APPLICATION FOR A CERTIFICATE OF APPROPRIATENESS – STAFF REPORT

084-18-CA 404 ELM STREET
Applicant: SUSAN S IDDINGS
Received: 5/16/18
Submission date + 90 days: 8/14/2018

Nature of Project: Install 64" wood privacy fence, gates and 9' tall arbor; install 48" welded wire metal fence

SITE PLAN
Scale: 1/32" = 1'-0"
NOTE: NEW CONSTRUCTION
DRAWN ON SITE SURVEY BY
JEFF DAVIS, PLS

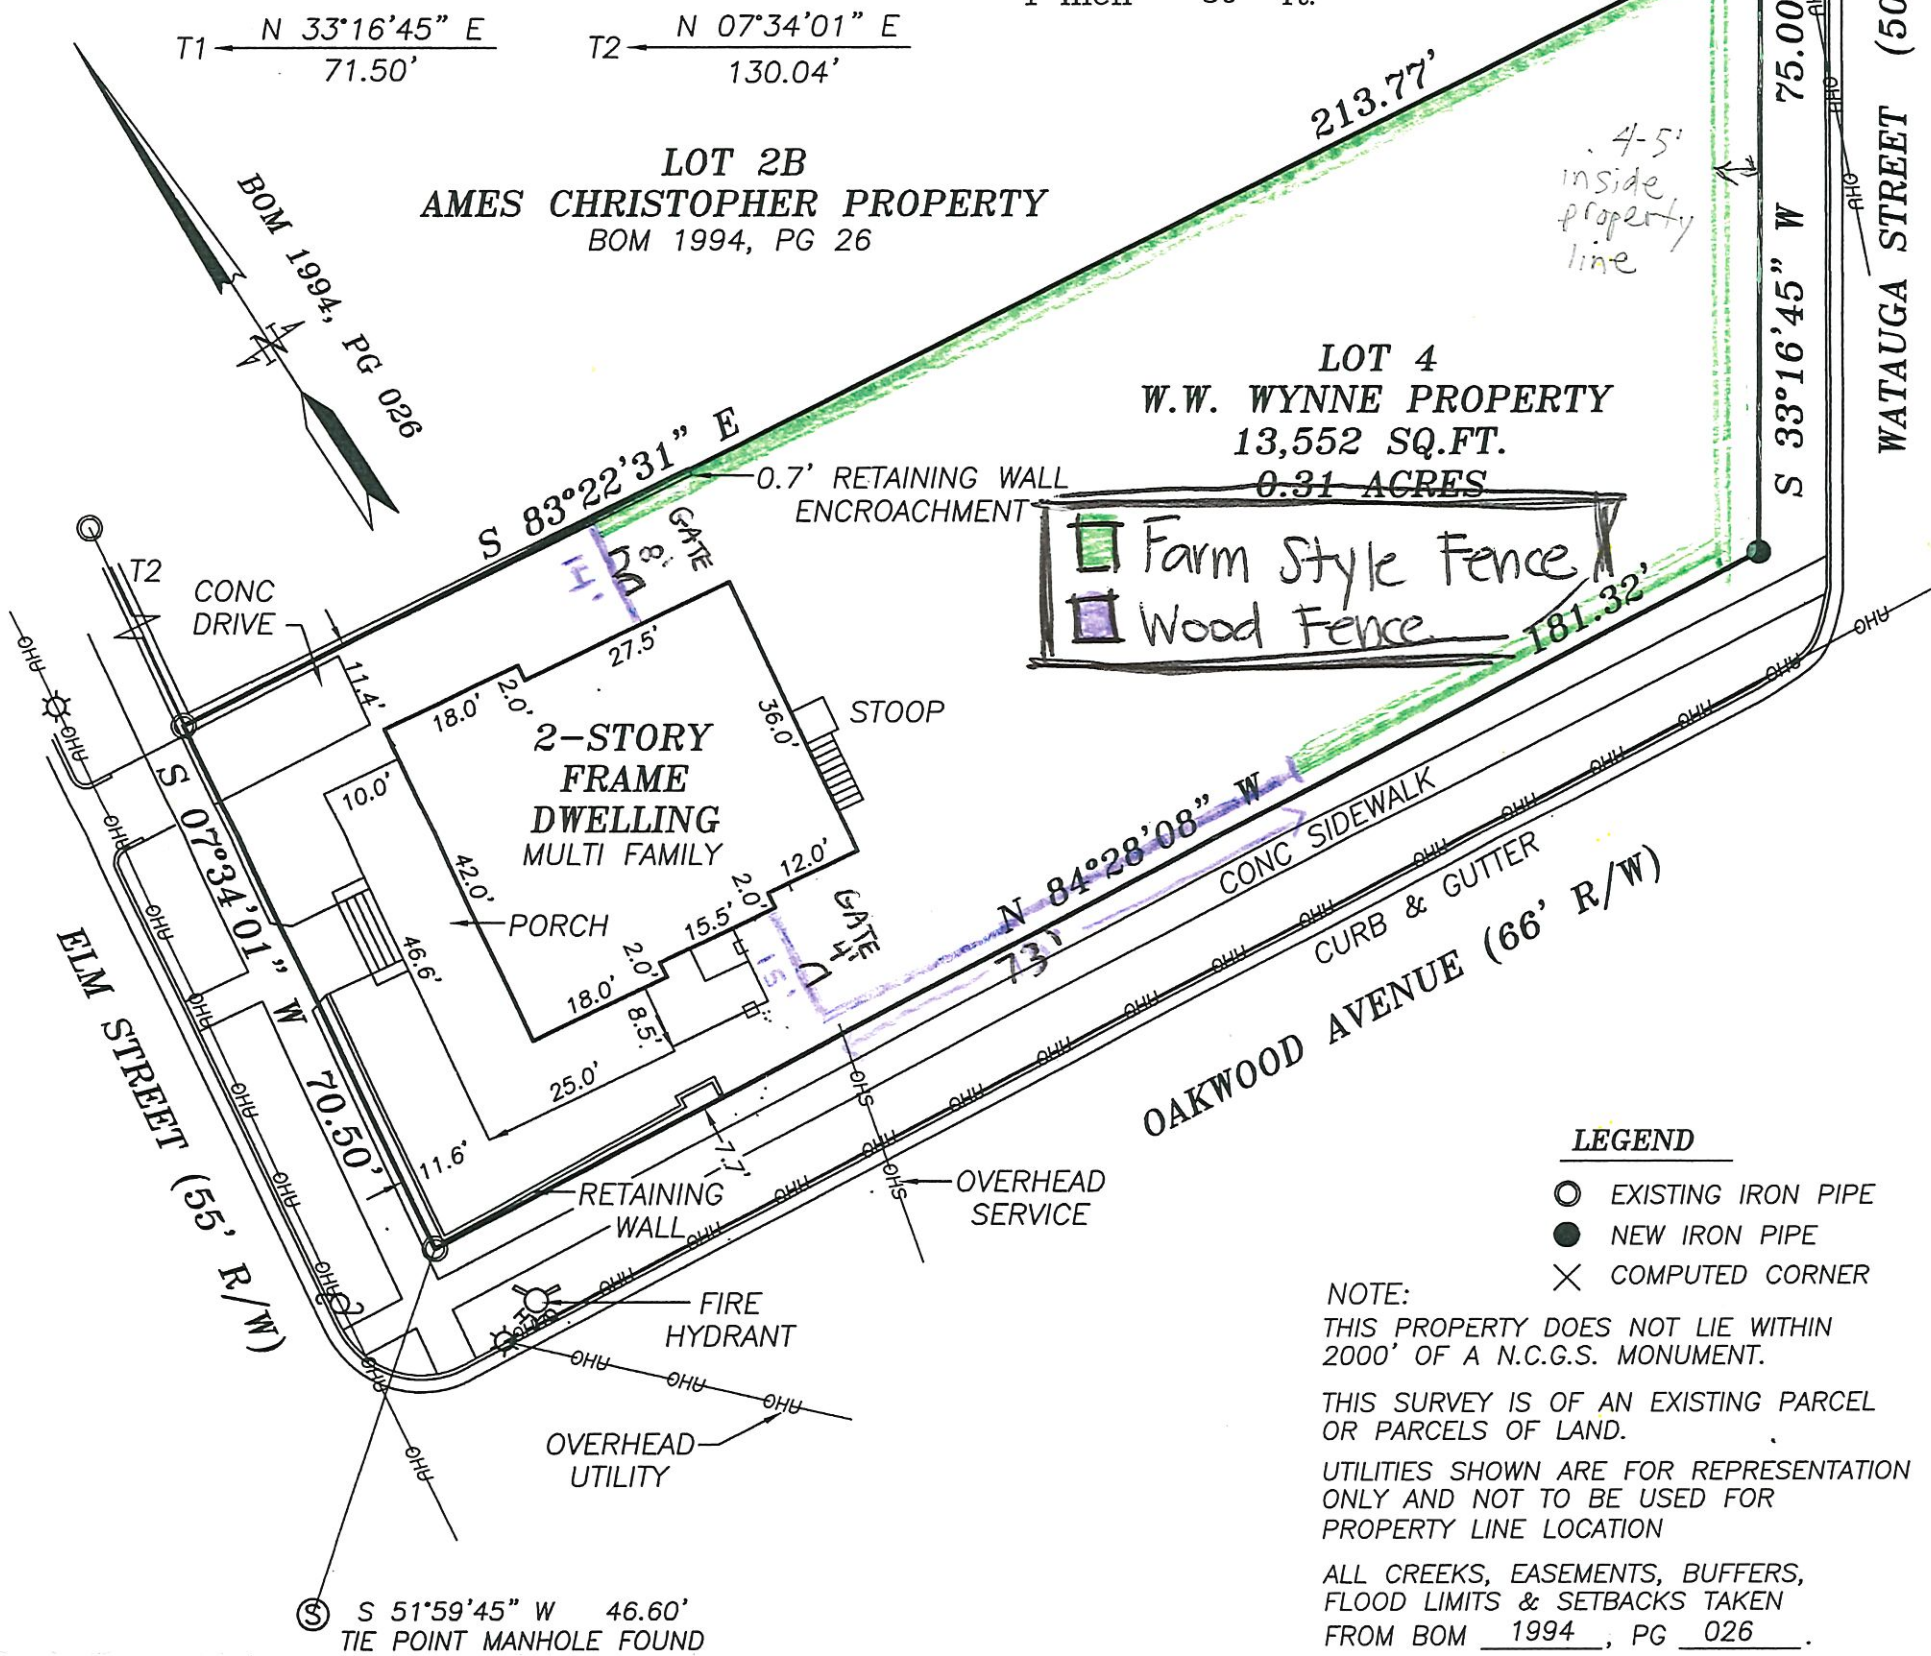
- Please provide a larger version of the site plan so that the detail can be easily read. The COA Committee generally prefers site plan drawings on 11"x17" paper. It may also be helpful to increase the line weight for the two different fence types since the base drawing has a lot of detail to begin with.

- The site plan shows some confusing information that should be corrected for clarity. There is an 8' wide gate on the north side of the house, while the south side gate appears to be labeled 15'. There is also a 73' measurement in red on the south property line, but it is unclear what that is measuring.

The south side gate will be 8' wide. The distance between the house and the north property line is approximately 14' 4". We will need about 6' 8" of fixed wood fencing in addition to the gate to fill this 14' 4" distance. The south side gate will be 4' wide. The length of the wood fence on the south side facing west, including the gate, will be 15'. The fence turns a corner at that point and extends 73' to the east. After 73', the wood fence will meet the welded wire Farm Style Fence on this south side.

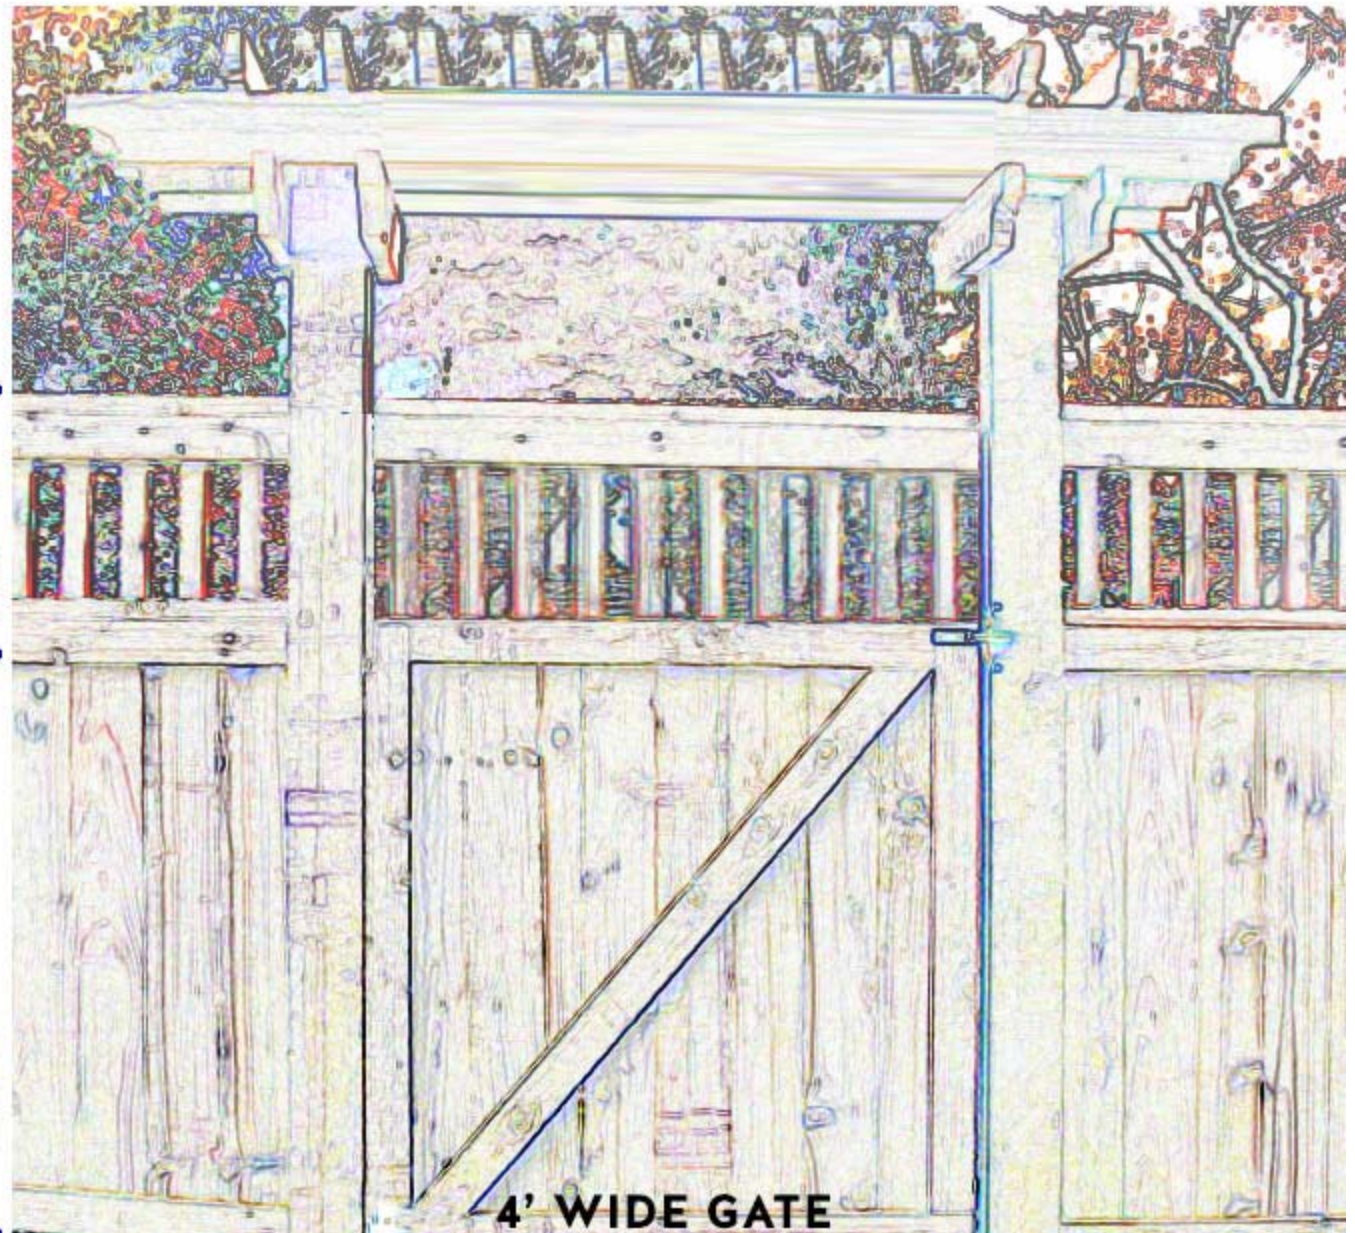
- Your application states that you are proposing a 64" tall fence, however it appears to be only 62" in height since the shadowbox fence is 44" and the wood slats are 18". Please clarify.

- Please provide a scaled drawing of the arbor and gate since the description varies from the photo provided in the application. Include height measurements showing the top of the fence and the top of the arbor.

**ARBOR TOP: 3 2"X8"X7' BOARDS SPACED 8" APART
(2X6" TRIM PIECES)**

**ARBOR
TOTAL HEIGHT 9'**

**44" HIGH
PRIVACY FENCE
(1X6" BOARDS)**

I was incorrect to call it a shadowbox fence. The wooden fence is a fence consisting of two parts. The bottom part is a picket fence with 6" wide boards side by side with no spacing between boards. The top part consists of 3" wide wood slats with approximately 2" spaces between each board. I say approximately, because the fence contractor might want to have a slightly different size space to make the fence slats fit right. The proposed height to the top of fence is 64". The bottom of the fence will be 2" above the ground. This 2" space accounts for the discrepancy between the 64" fence height and the 62" (44 plus 18) stated above. I plan to use #2 grade pine, the highest quality pine I was told the fence contractor Seegars Fences uses.
